REPORT

File: PDP 16-01 AR 15-34

RE: Planned Development Permit 16-01 and Architectural Review 15-34 (Lava Ridge Apartments) – Vacant Lot Located at the Southeast Corner of Highway 32 and Bruce Road

ATTACHMENT F

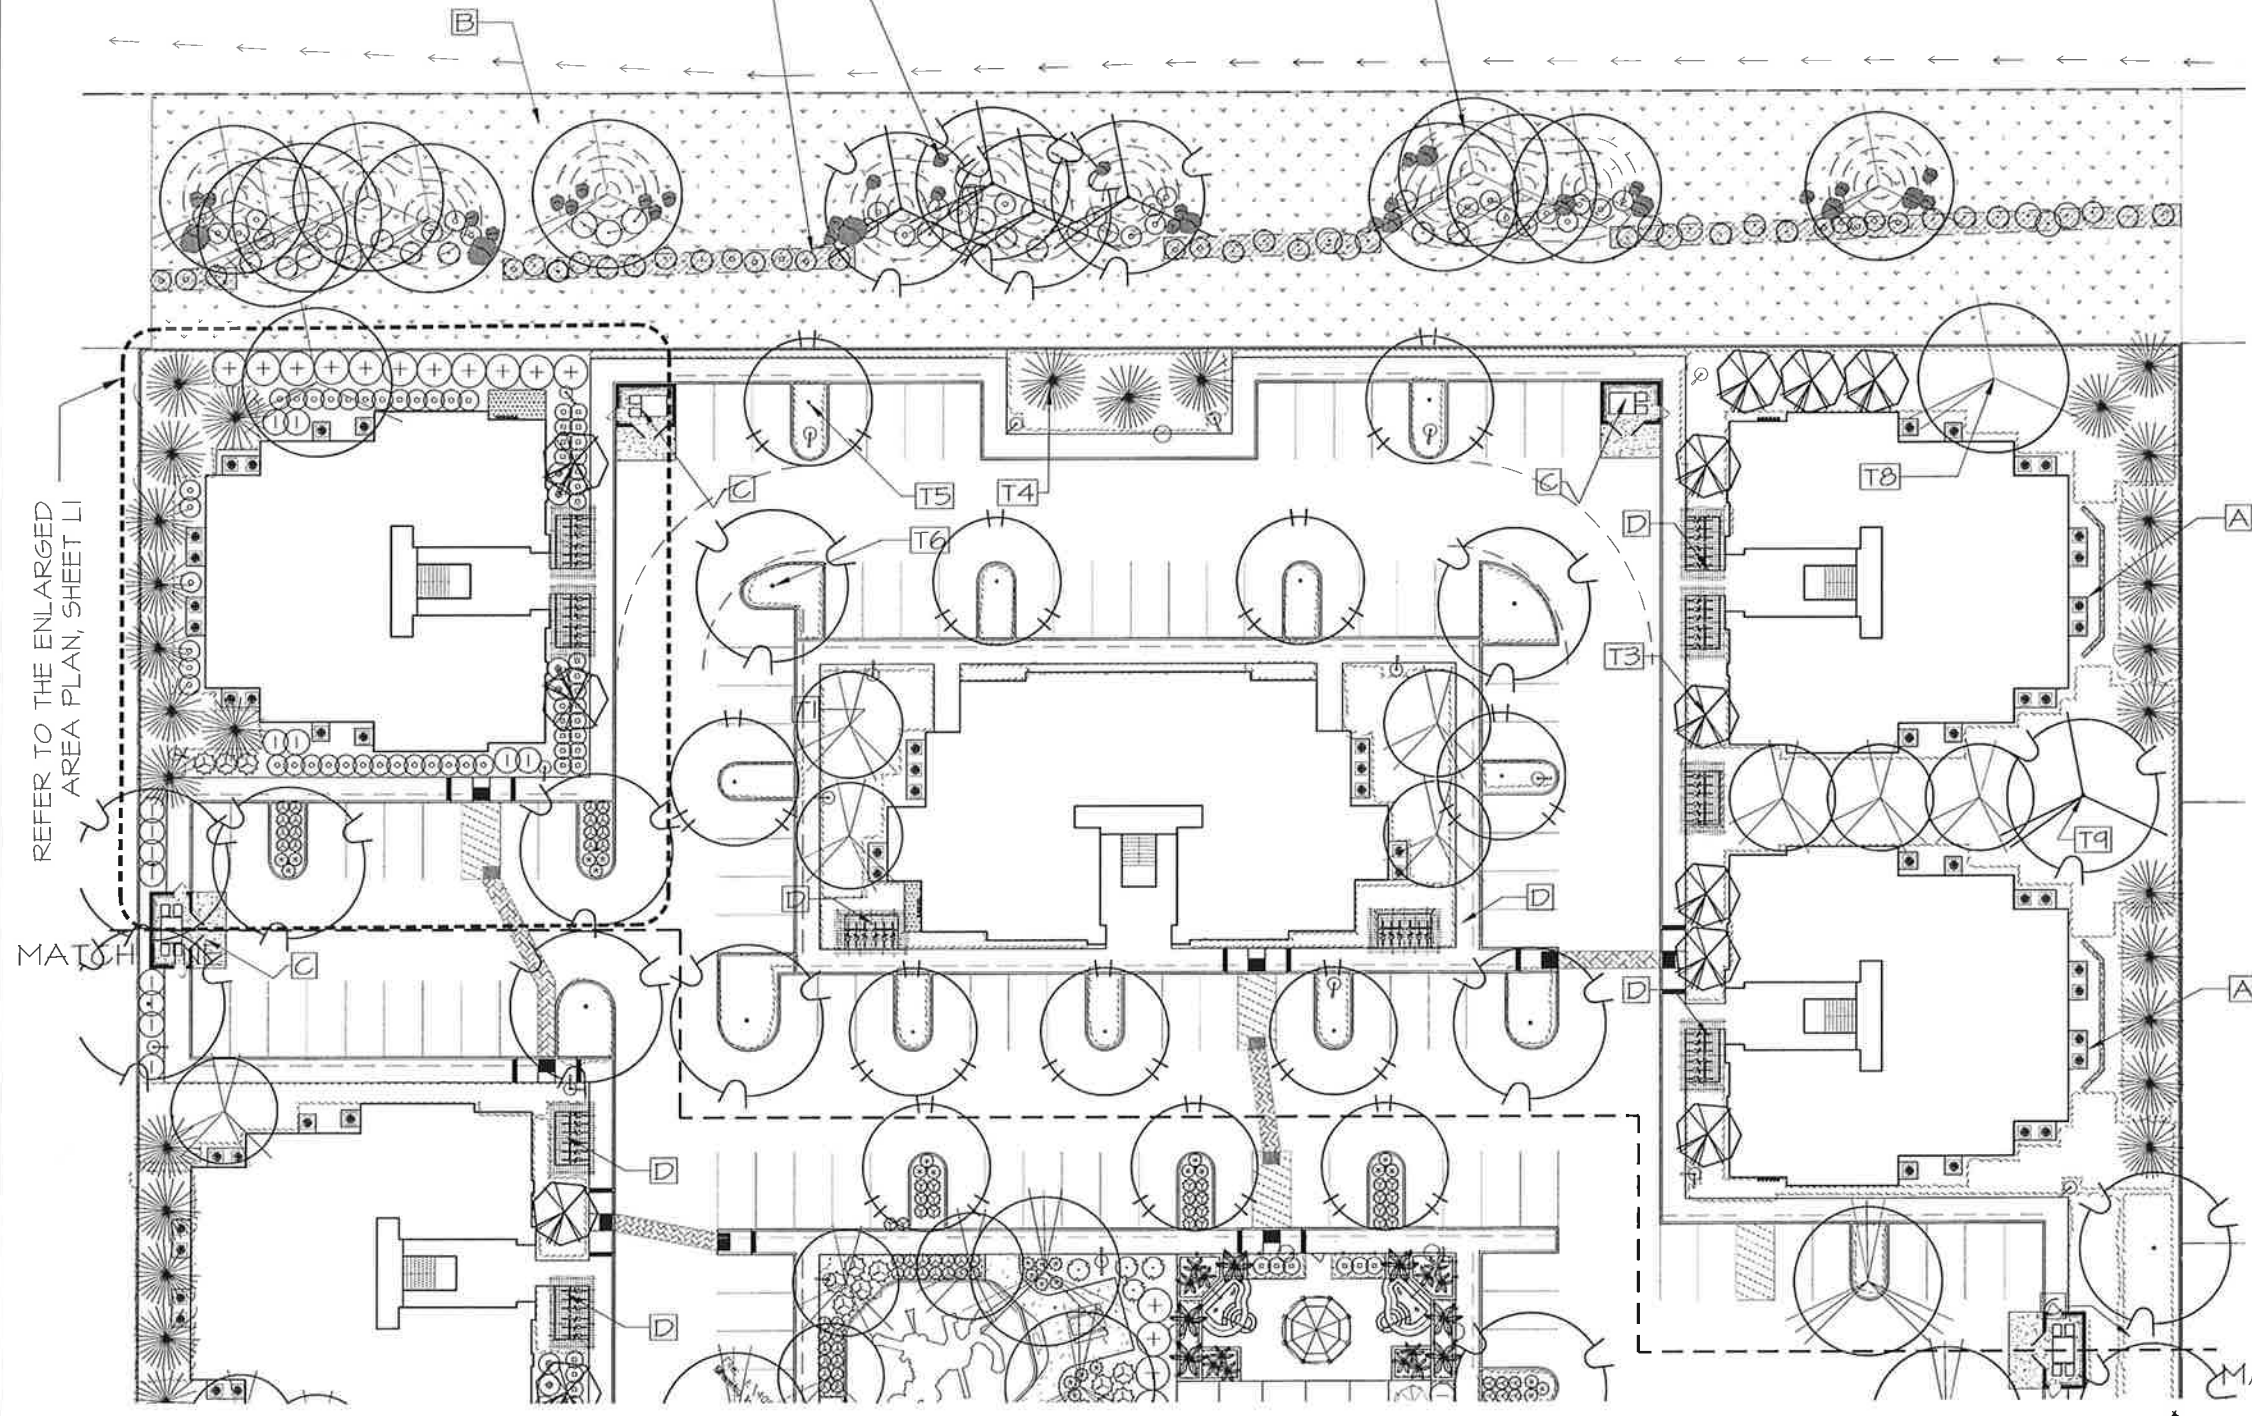
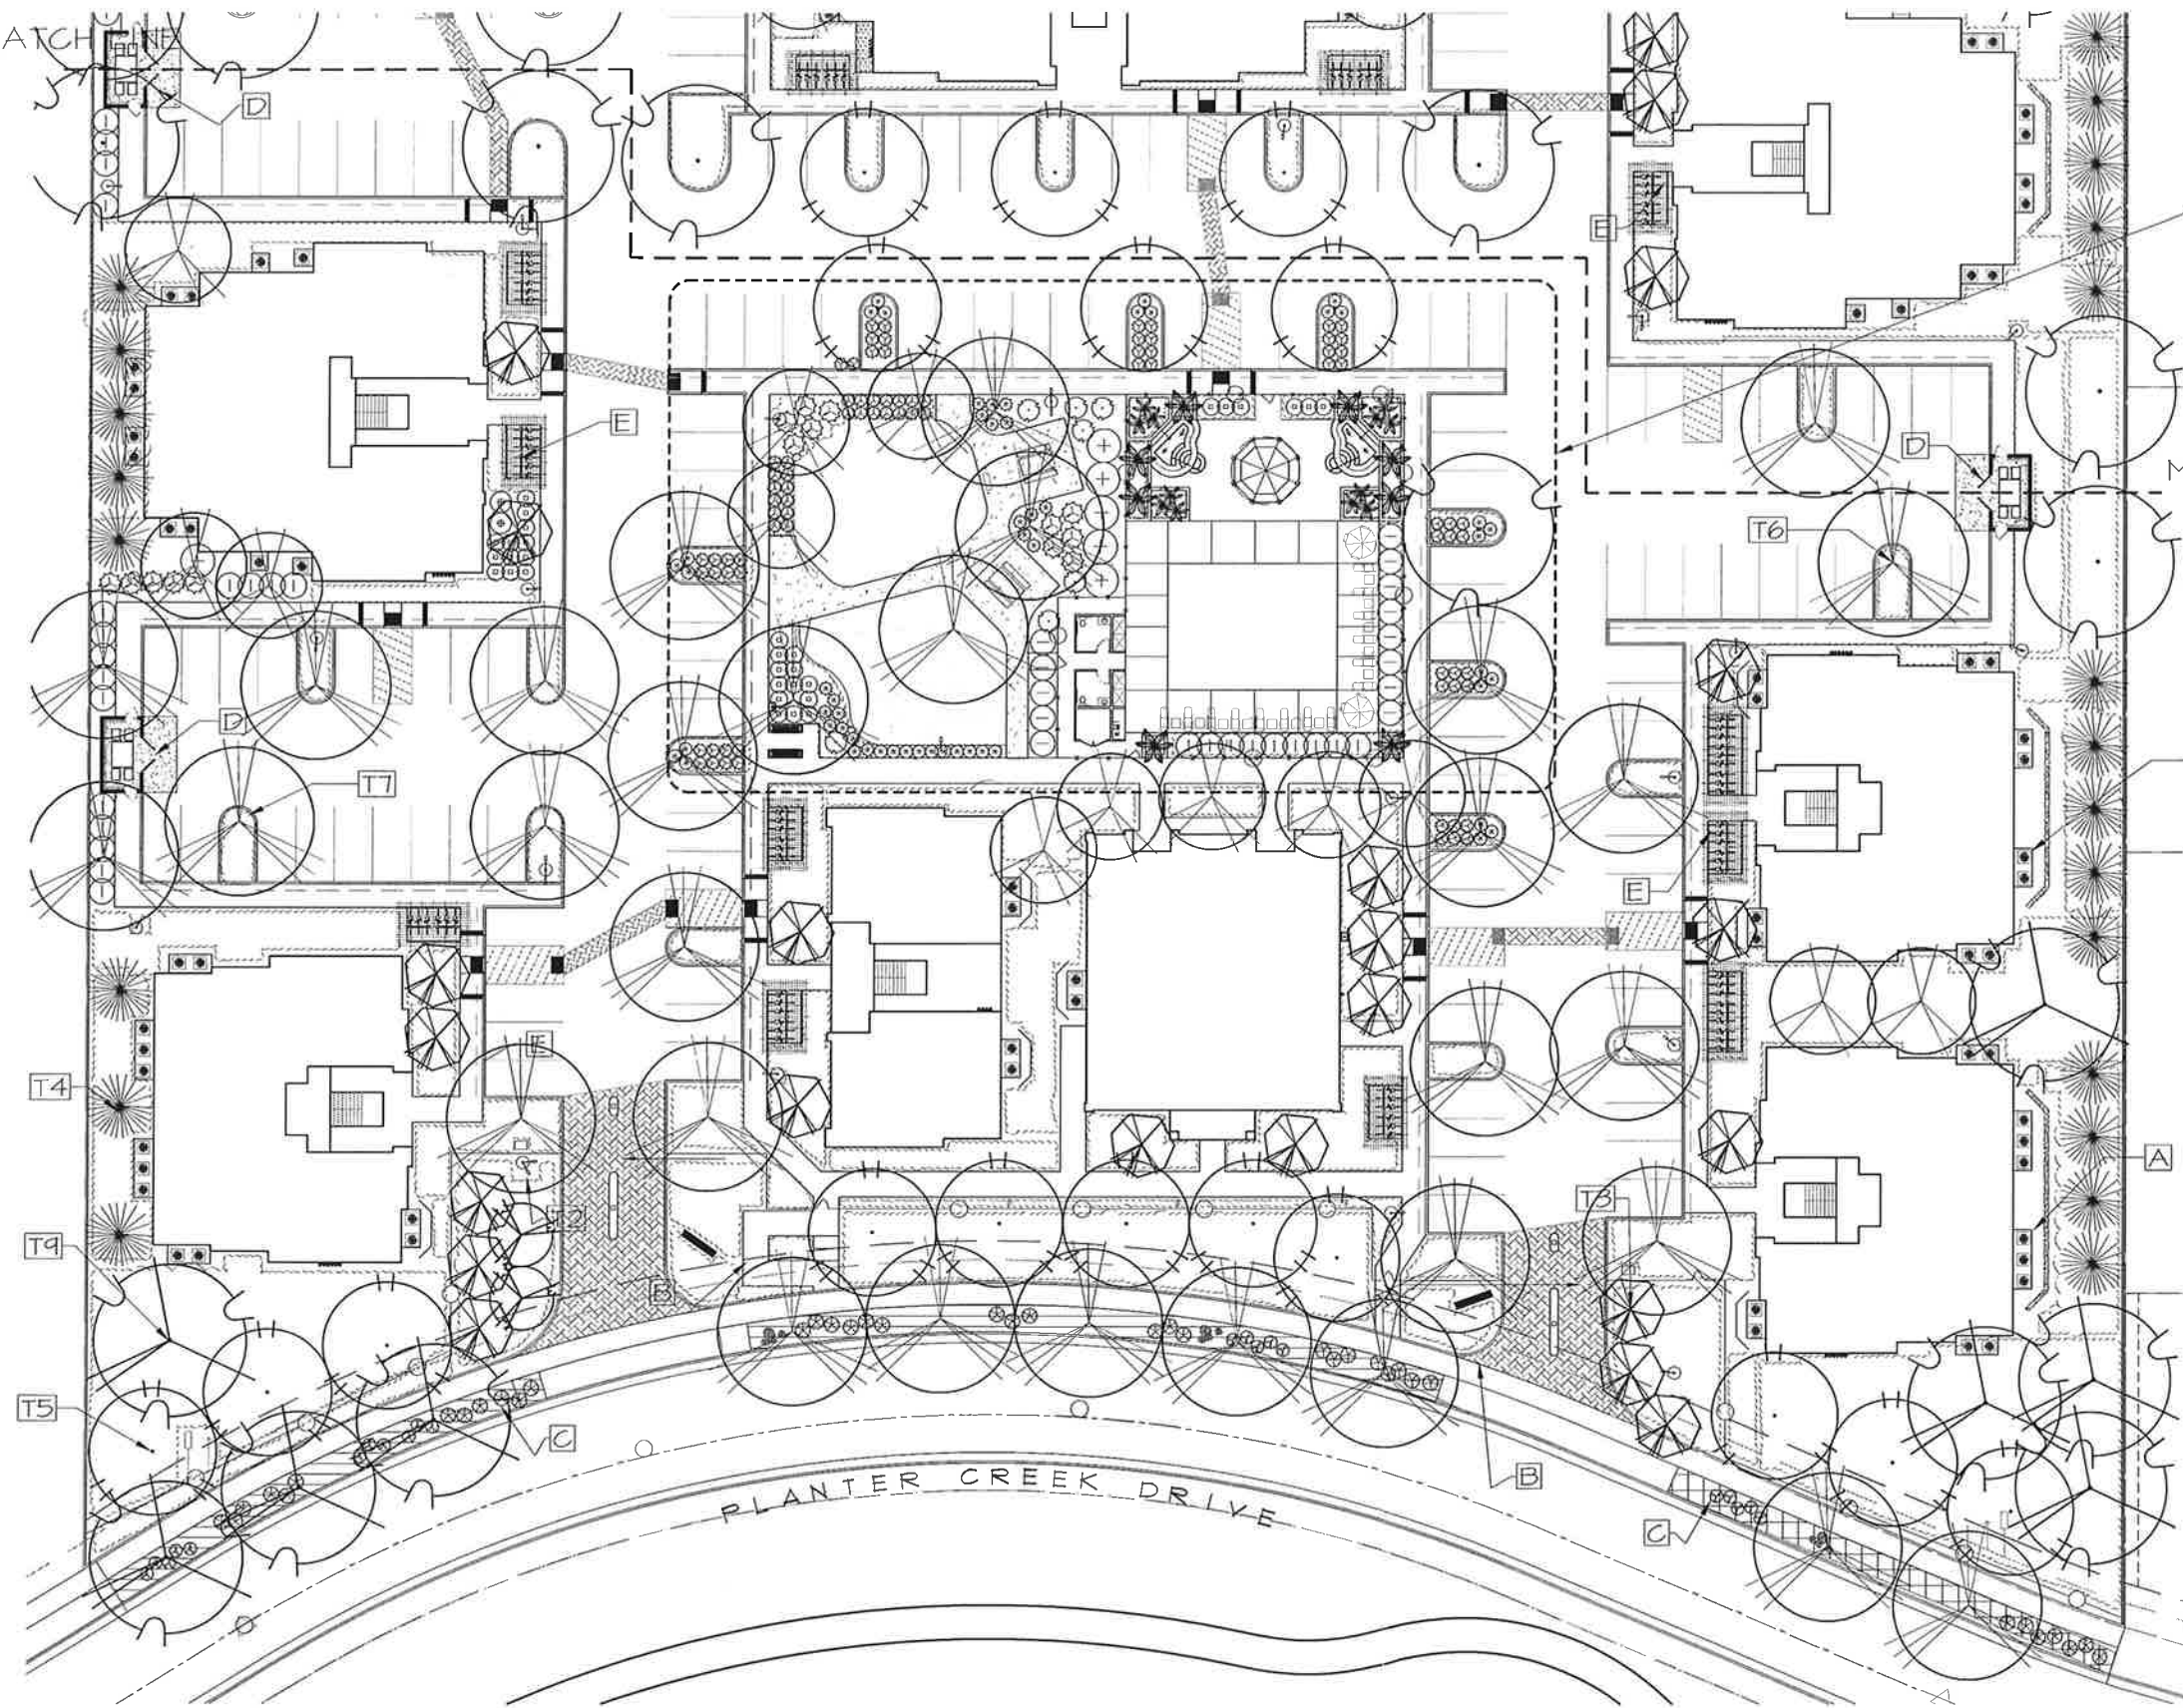
Landscaping throughout the project site utilizes ten different tree species to both meet the 50 percent shade requirement, and to bring additional colors and interest into the project (see Landscape Plan, **Attachment F**). However, some of the proposed tree species, such as the Canary Pine and Strawberry Tree, may not be appropriate for the location due to the foothill setting, therefore staff recommends a condition of approval requiring that the landscape plan be modified to include the addition of more site appropriate trees with a preference towards native or near natives. Turf area is minimized and only used near the play structure, with picnic tables nearby. Additional landscaping is provided in the setback areas of the site, in the dog park, and along the Highway 32. Shrubs, ground cover and creeping vine are placed and utilized to minimize views into the pool from the parking lots and to soften trash enclosures.

Proposed landscape design would provide a variety of plantings that repeat in harmony with the pattern of spaces provided between the new units. The landscape plan has been conditioned to introduce additional native and near native trees, while removing tree species that are not conducive to the foothill setting. Screening of utilities are done with creeping vines to provide further interest to the project, while also softening the structures. Overall, landscaping will have a range of colors, and textures that will provide visual interest throughout the year.

7. Landscape plan shall be modified to remove Canary Pine and Strawberry Tree and introduce more native or near native species.
